## GENESEE COUNTY PLANNING BOARD REFERRALS NOTICE OF FINAL ACTION

**C-02-BAT-02-25**

**Special Use Permit to operate an architectural design services office.**

**4 Mix Pl., Batavia**

A001  
sheet number

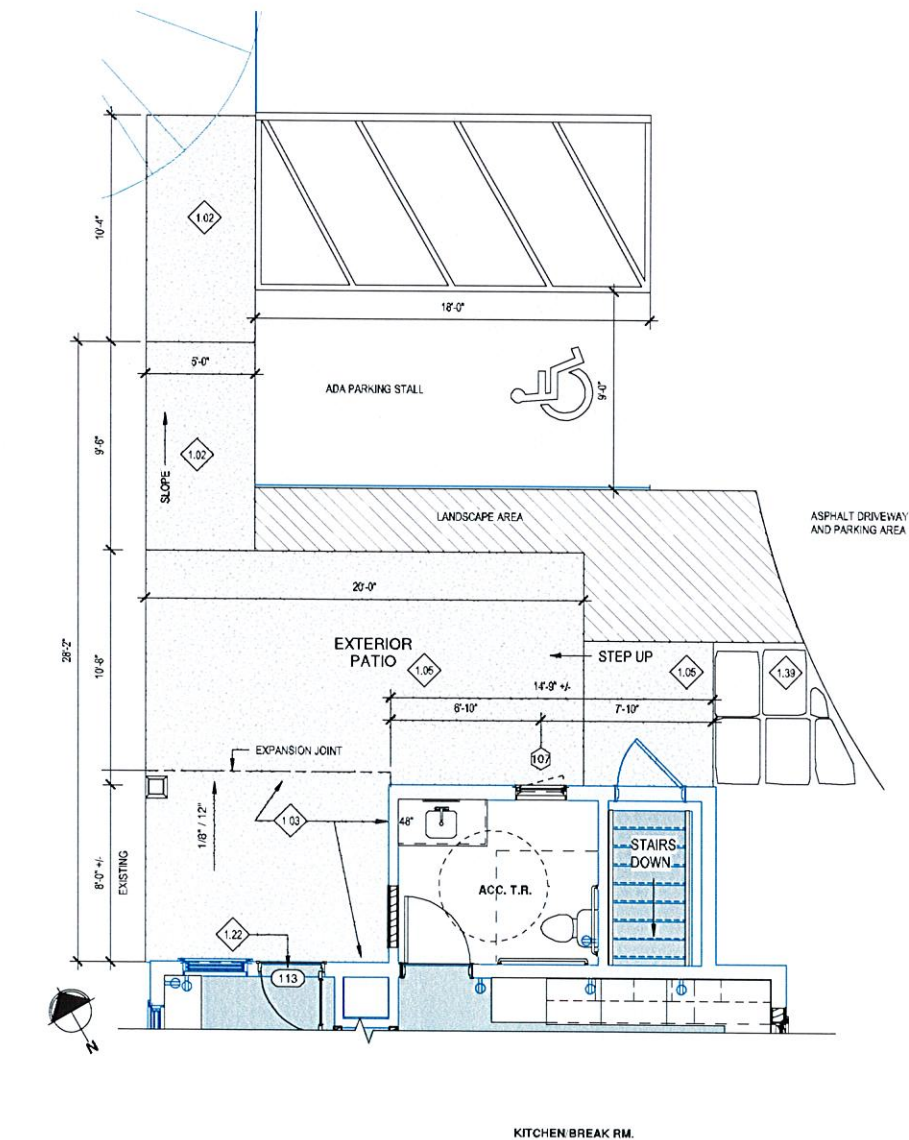
1) BMC 190-37 B (5) Two parking spaces are indicated in the front yard along the eastern lot line. No parking is permitted in the front yard.

2) BMC190-37 B (6) 6 parking spaces are proposed along the eastern lot line within 20' of the neighboring residential property. It appears you are proposing to utilize the neighbor's existing fencing as part of the required screening for this projects parking areas. For the PDC's consideration, please provide details on how you plan to control maintenance of this screening.

3) BMC 190-37 B (9)(a) [6] Provide a refuse storage plan.

5) BMC 190-37 B (9)(a) [9] Provide storm water drainage plan.

**Response:** The two proposed parking spaces have been removed from the front yard and placed to the north in the rear yard parking area, as indicated on revised sheet A001.

**Response:** We will coordinate with the neighbors to share the expense in the event that the fence becomes deteriorated and must be repaired or replaced to continue to perform as a required screen of the parking areas.

**Response:** The office does not produce an excessive amount of waste. We anticipate one 90 gallon tote for waste and one 90 gallon tote for recycling. The totes will be stored in the shed to the east of the house.

Response: The expanded asphalt parking area will be sheet-drained toward the center of the property to avoid run-off toward neighboring properties.

A201

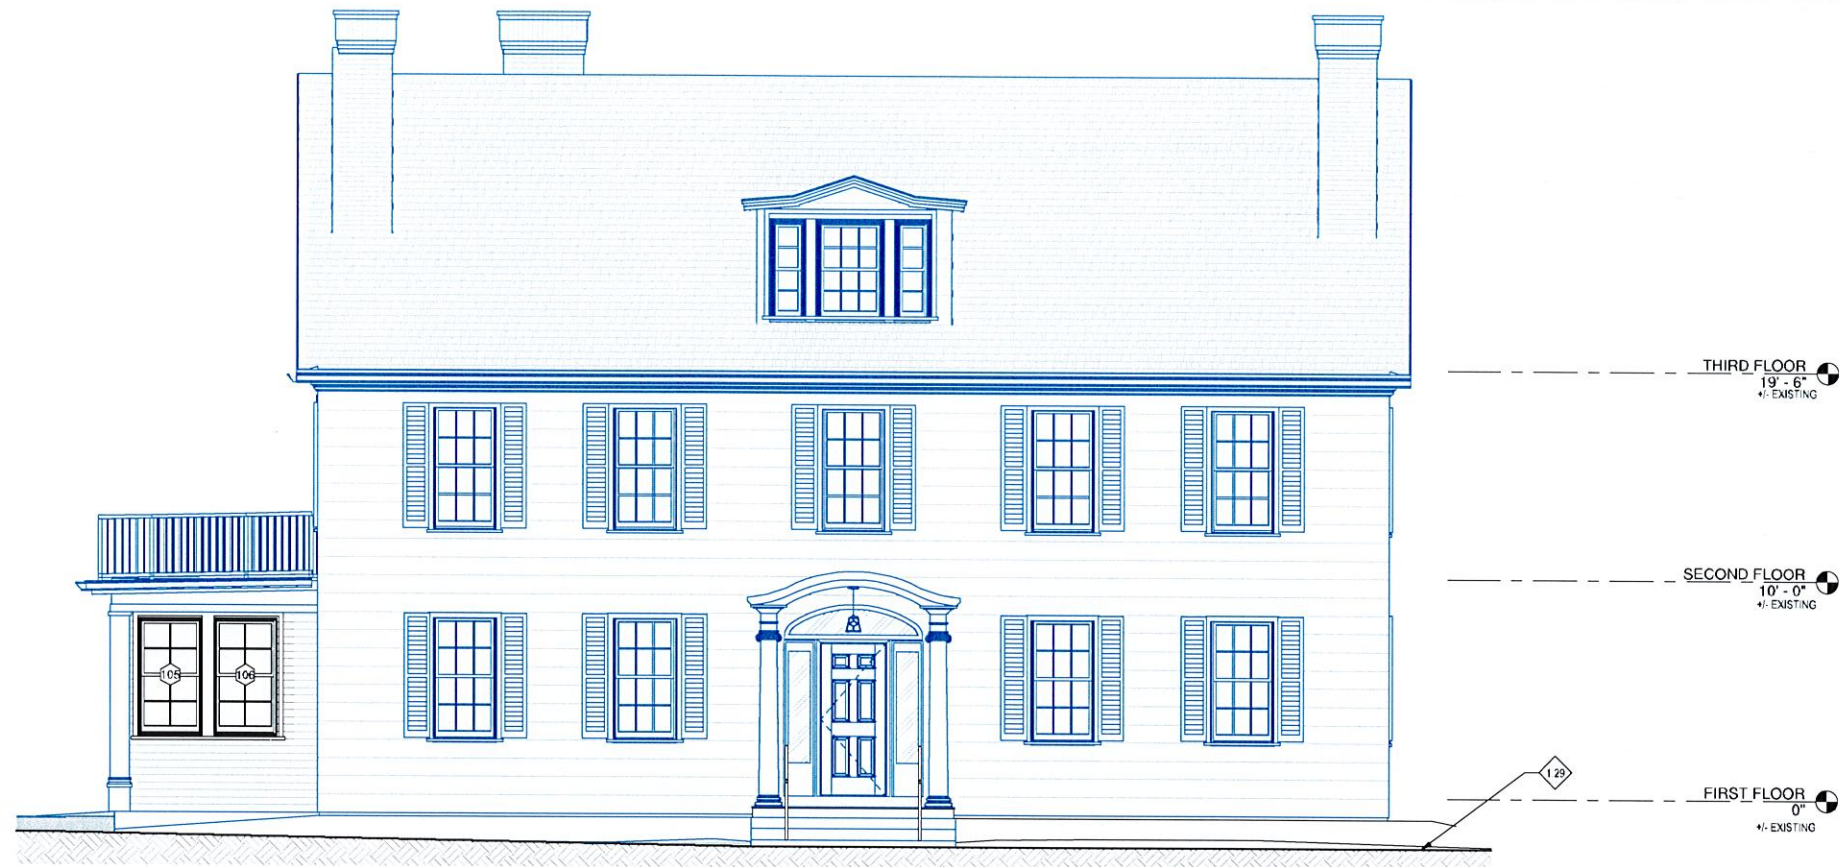
4) BMC 190-37 B (9)(a) [7] Provide signage details.

**Response:** We are proposing a 1.89 sf wall sign (2.0 sf allowed) to be mounted to the right of the front door that faces Mix Place, just below the existing address sign "4 Mix Place." The new sign will be a 1'-5"H x 1'-4" W hammered stainless steel background with the company name "smartDESIGN architecture" on two lines in 1-3/8" tall raised letters and logo in 4-3/8" backlit raised letters. See provided detail on revised sheet A201.
